ADDENDUM NO. 1

ISSUE DATE: **May 3, 2018**

RE: **Sterling Hall Renovation for TREX Physics**
University of Wisconsin-Madison
Madison, Wisconsin
UW-Madison Project No. **0057-1701**
UWSA Project No. **A-17-003**

FROM: KEE Architecture, Inc.
621 Williamson Street
Madison, Wisconsin 53703

Graphic Scale	
Project Numbers:	UWSA: A-17-00 MSN: 0057-170
Set Type:	BD
Date Issued:	04/06/2018
Sheet Number	M200

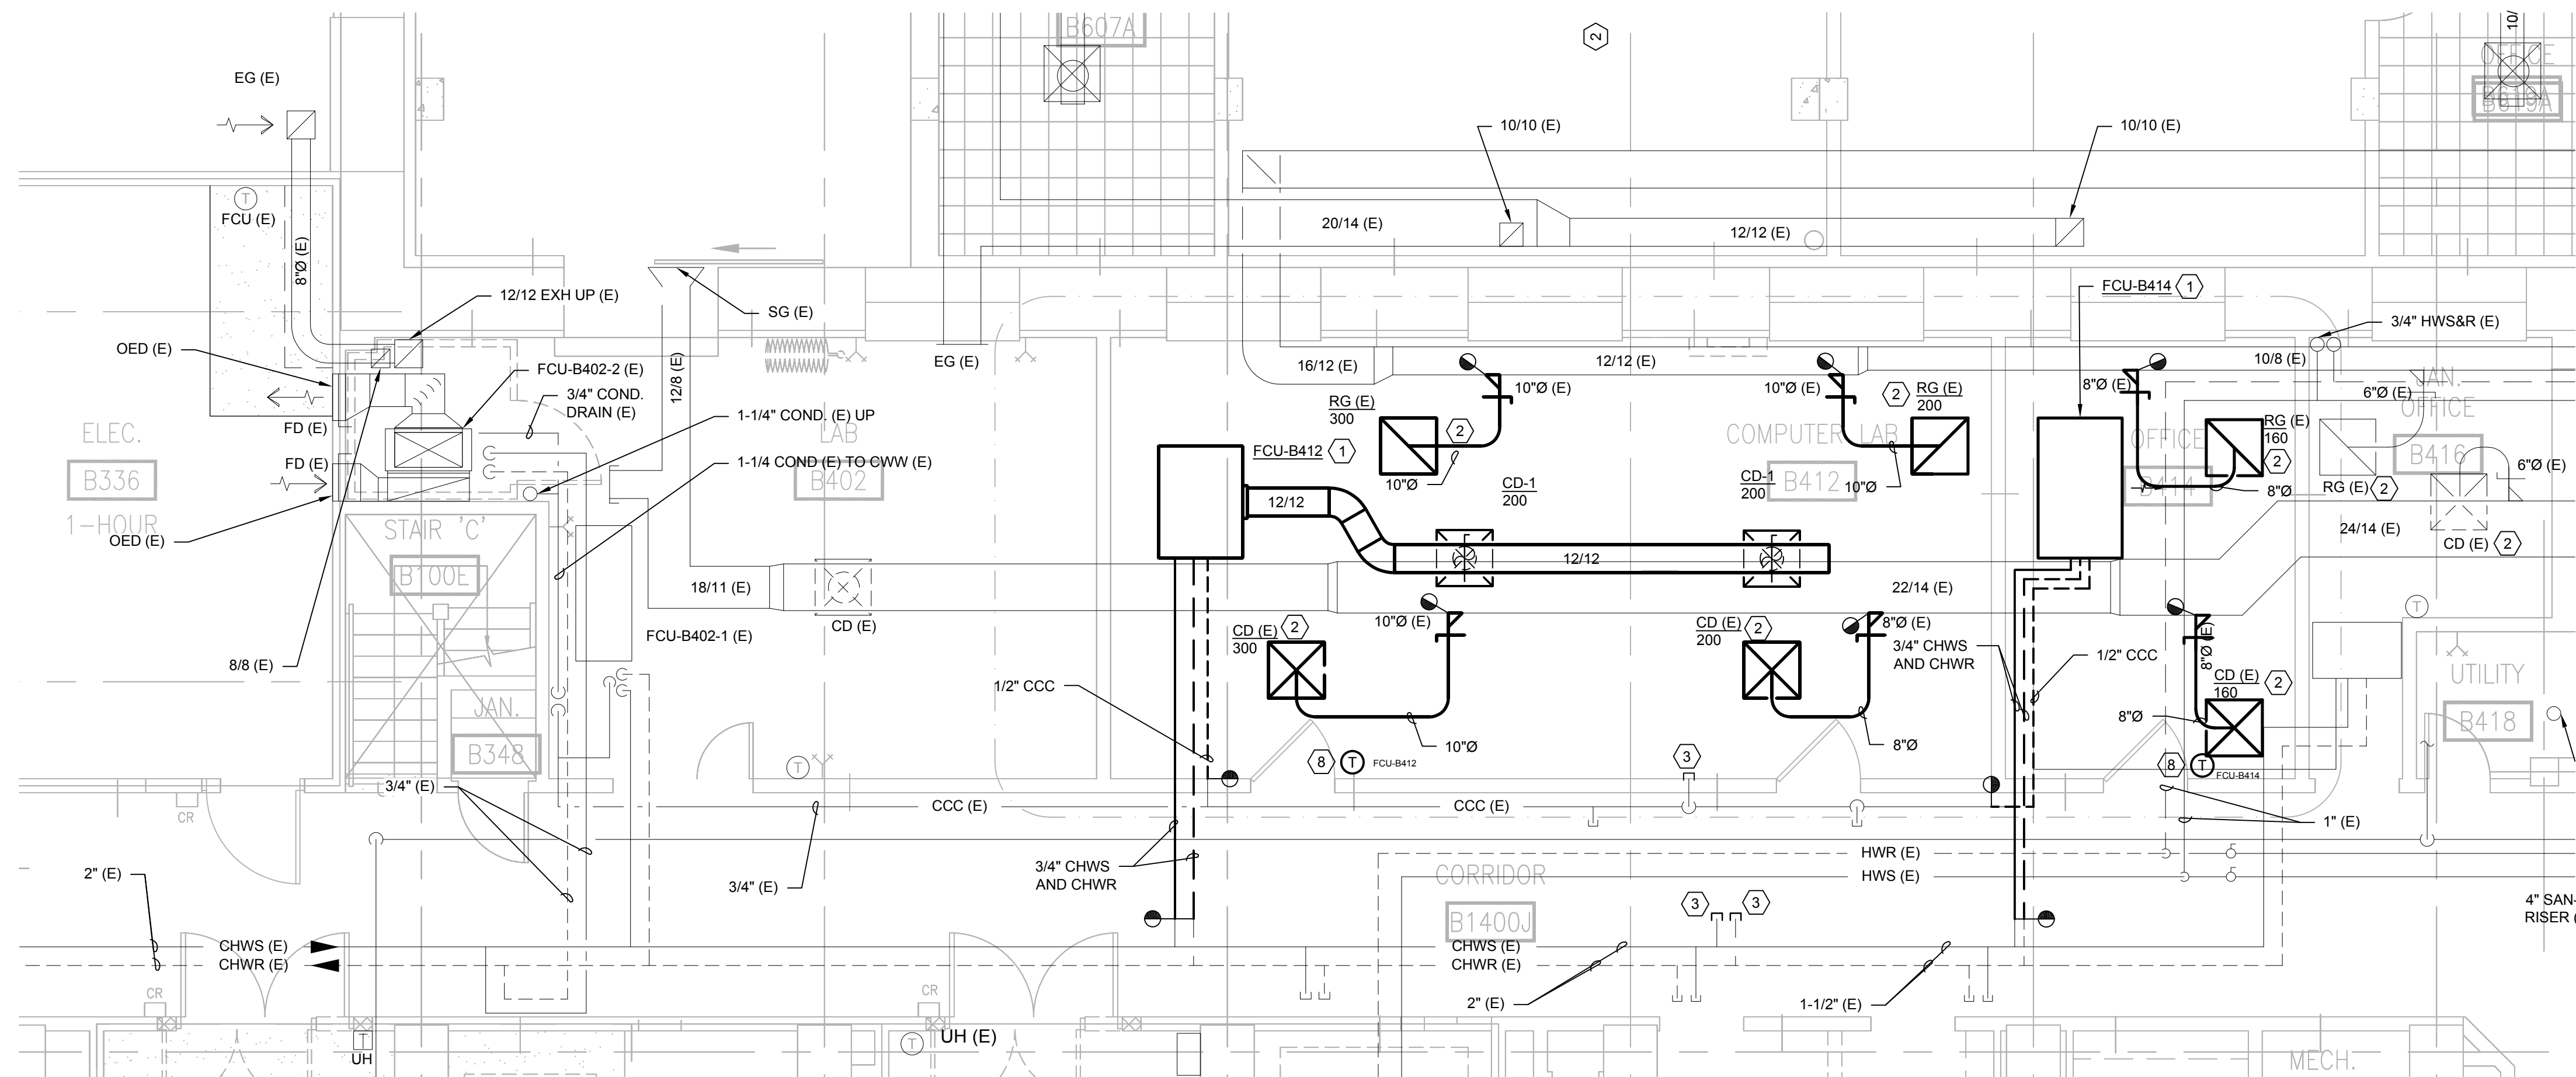
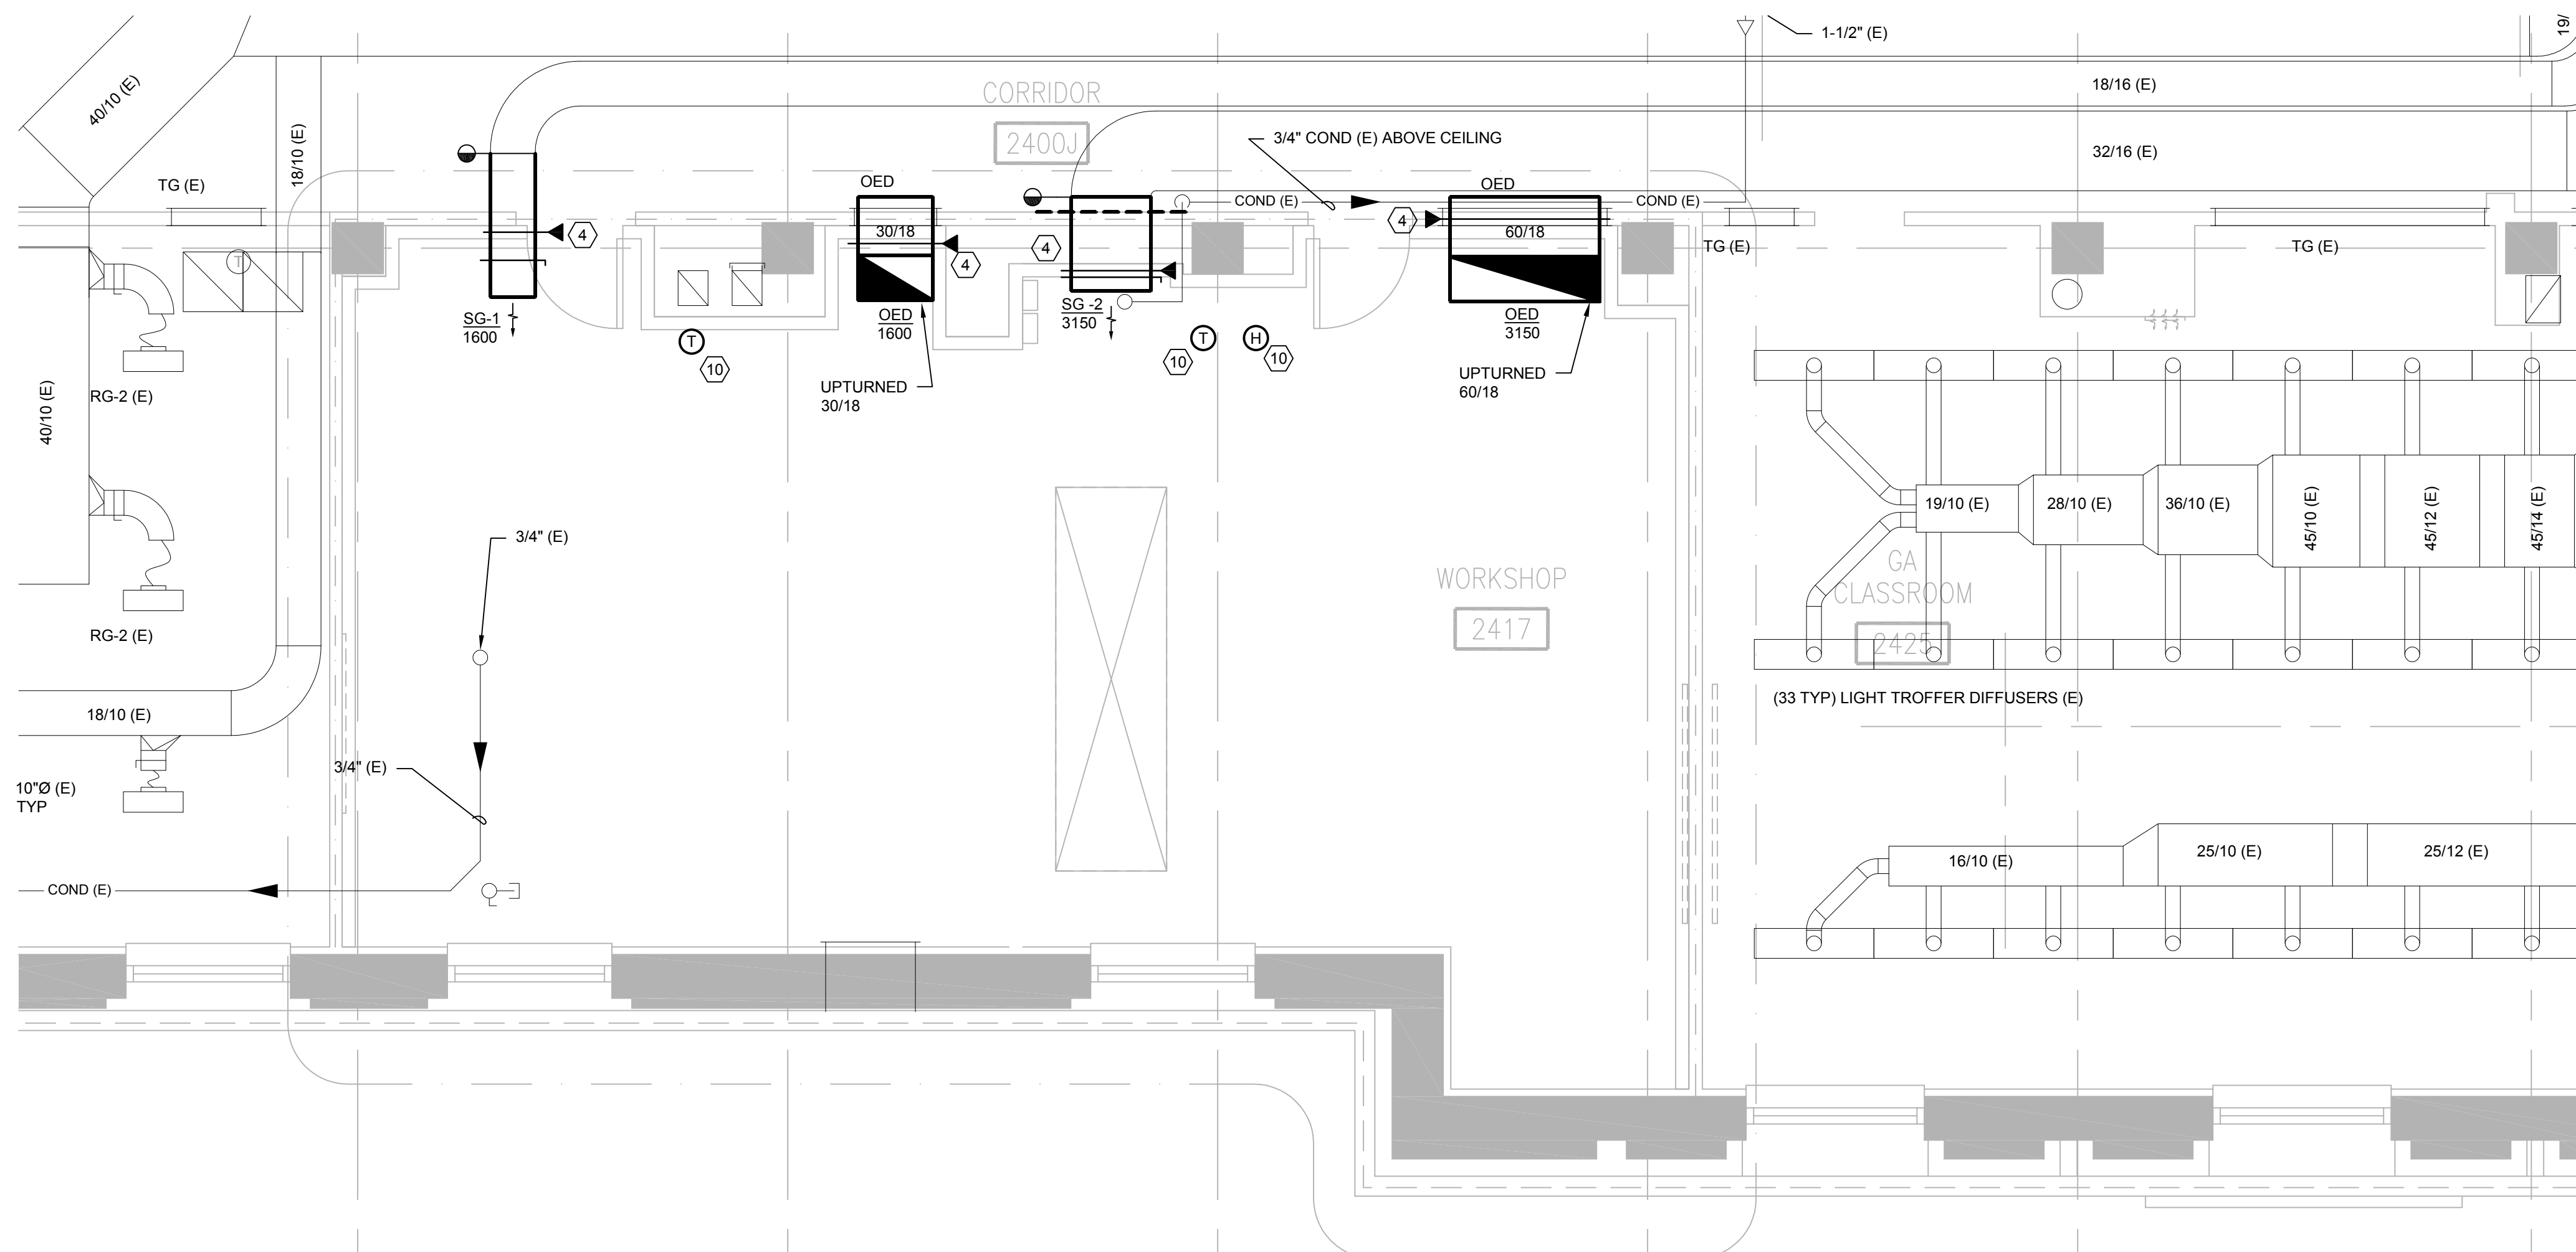
17 HX-3 city water back-up change-over valves. HC shall coordinate all new work with 23 09 24
18 contractor.”
19 b. Edited Keyed note 8 to read:
20 “23 09 14 contractor (UW DDC and steam fitter shops) to provide new pneumatic thermostat and
21 controls. HC shall coordinate all new work with 23 09 14 contractor.”
22 c. Edited Keyed not 10 to read:
23 “23 09 14 contractor (UW DDC and steam fitter shops) shall reinstall existing pneumatic control devices
24 saved from sheet M100. Connect reinstalled control device to existing pneumatic control lines saved in
25 room 2400J per sheet M100. HC shall coordinate all new work with 23 09 24 contractor.”
26
27 26. E000 - Symbols, Abbreviations, Details, and Schedules – Electrical: Replaced sheet:
28 a. Added fire shutter electrical detail 1/E000.
29 b. Revised Panel Schedule for 2417 PNL C.
30
31 27. E202 - Symbols, Abbreviations, Details, and Schedules – Electrical: Replaced sheet:

- 7 23 09 24 CONTRACTOR (UW DDC SHOP) TO PROVIDE NEW DDC CONTROLS WITHIN THE EXISTING CONTROL PANEL FOR HX-3 CITY WATER BACK-UP CHANGE-OVER VALVES. HC SHALL COORDINATE ALL NEW WORK WITH 23 09 24 CONTRACTOR.

- 8 23 09 14 CONTRACTOR (UW DDC AND STEAM FITTER SHOPS) TO PROVIDE NEW PNEUMATIC THERMOSTAT AND CONTROLS. HC SHALL COORDINATE ALL NEW WORK WITH 23 09 14 CONTRACTOR.

1 FIRE SHUTTER - ELECTRICAL
E000 SCALE: NONE

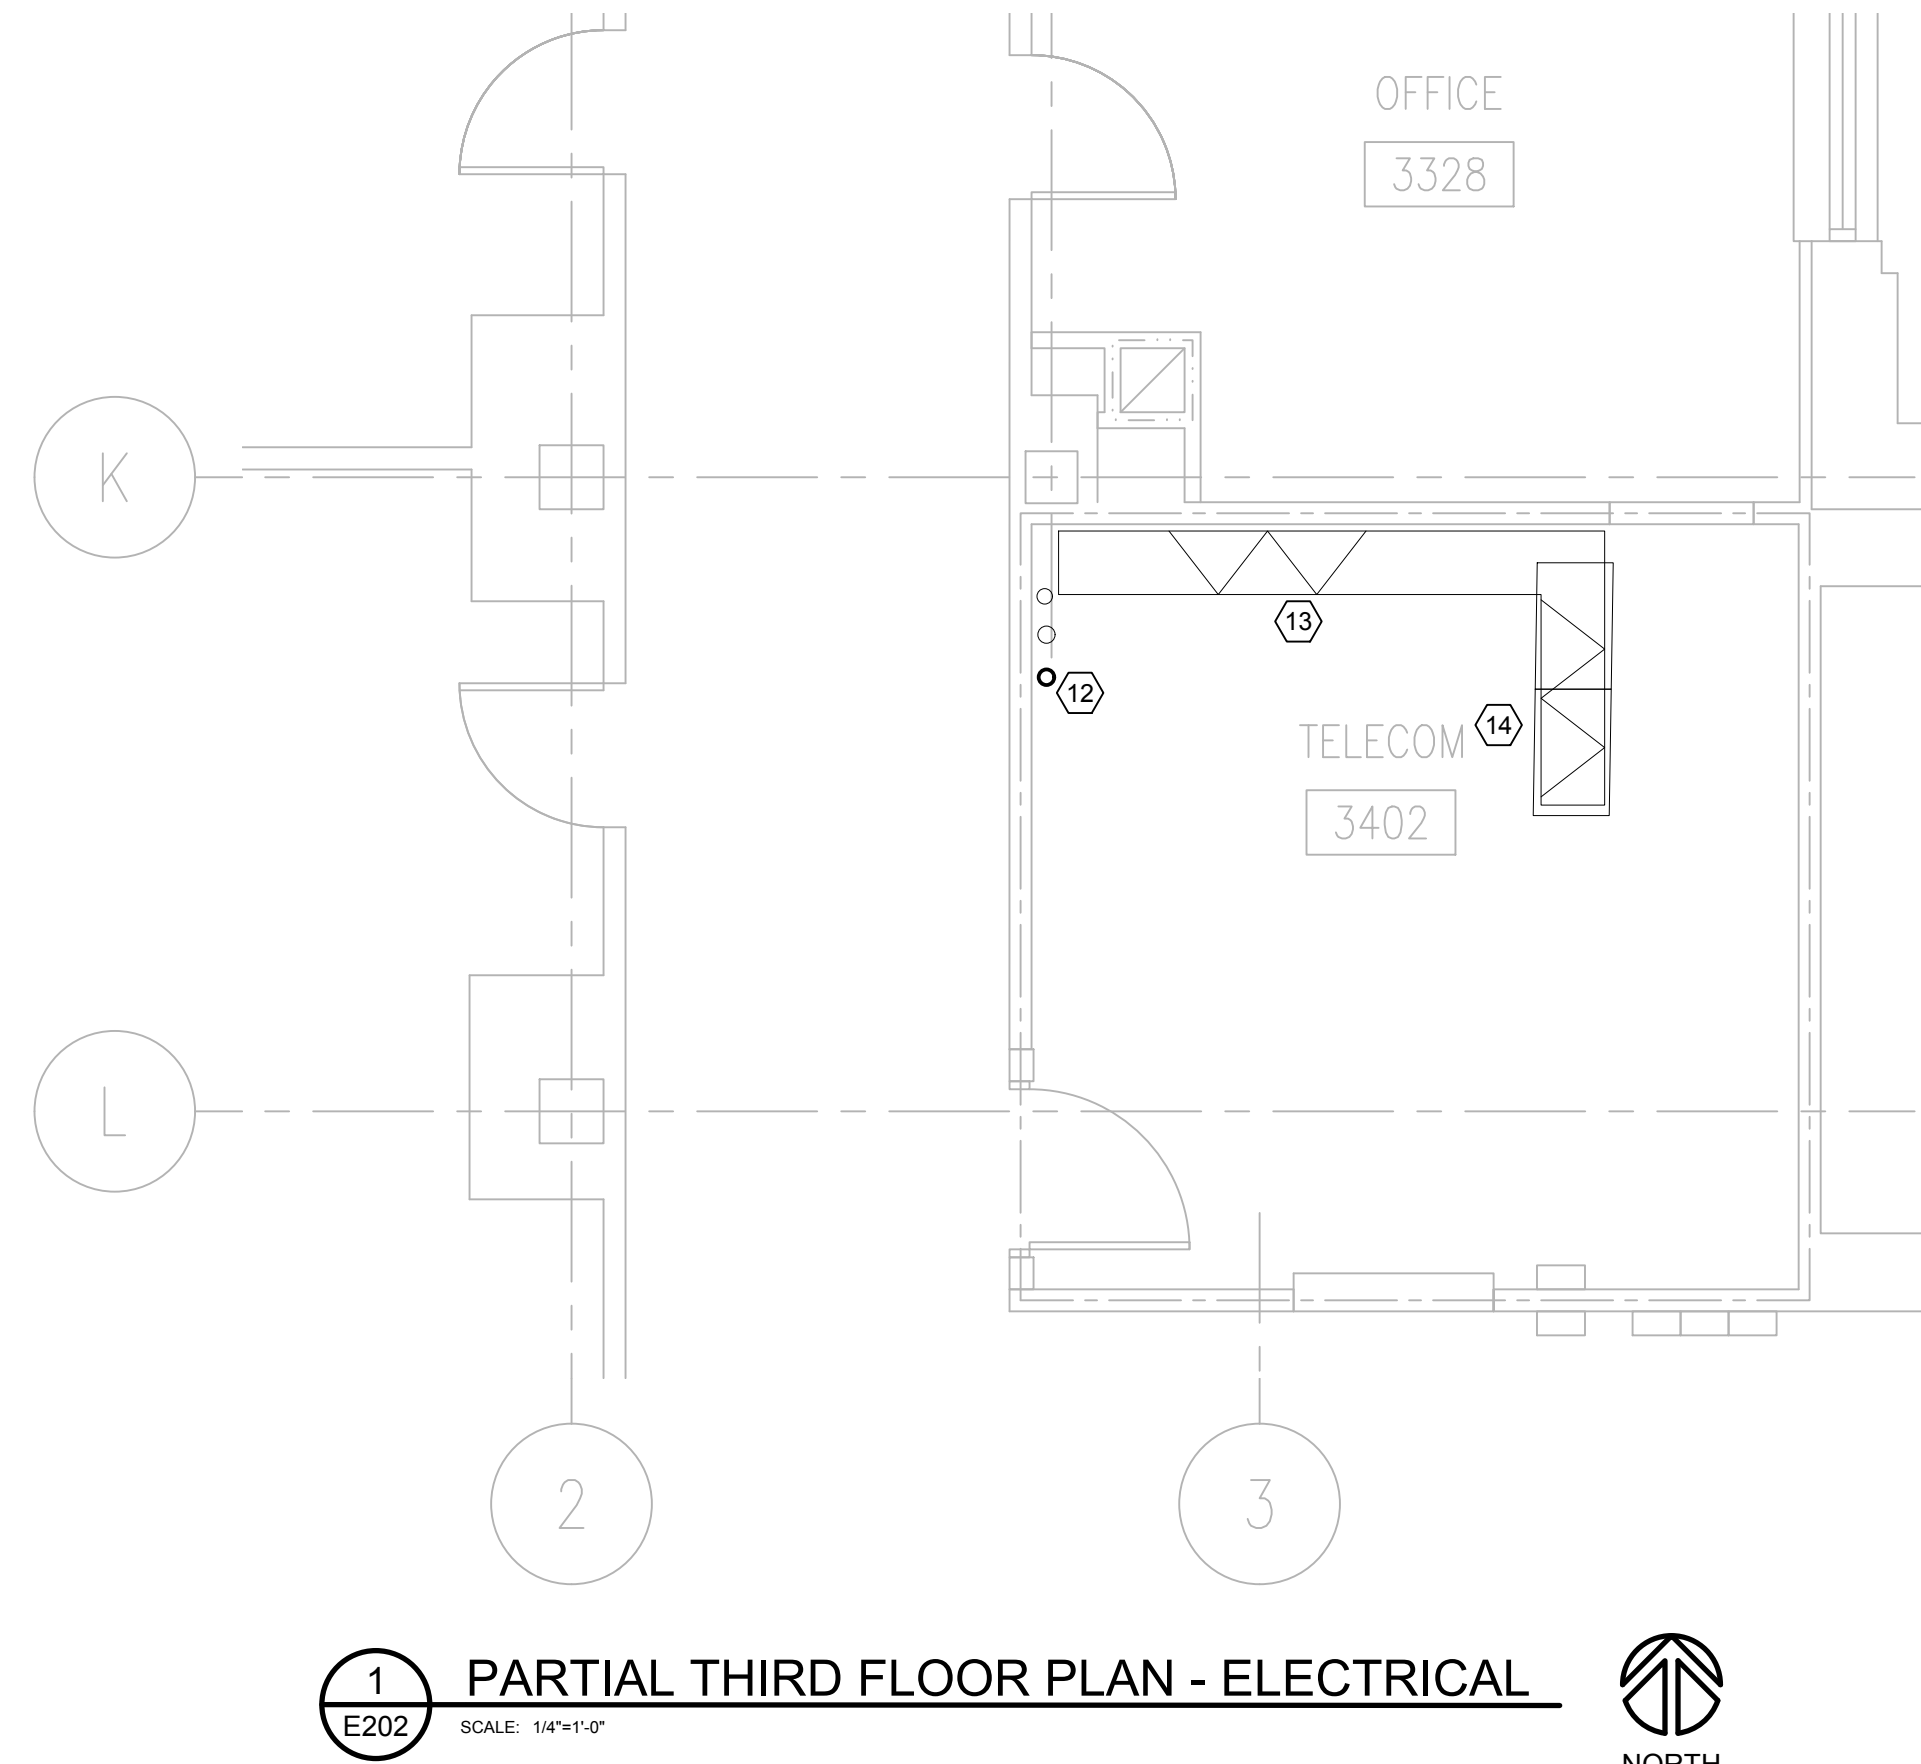
32 a. Added fire shutter connection.
33 b. Added Note 15.
34

- 14 PROVIDE NEW 48 PORT PATCH PANEL IN EXISTING IT RACK. PROVIDE ADDITIONAL WIRE MANAGEMENT FOR NEW CABLES.
- 15 EC TO PROVIDE WIRING FOR FIRE SHUTTER AS INDICATED ON DETAIL 1/E000. CONNECT TO 20 AMP, 120 VOLT CIRCUIT IN 2417 PNL C.
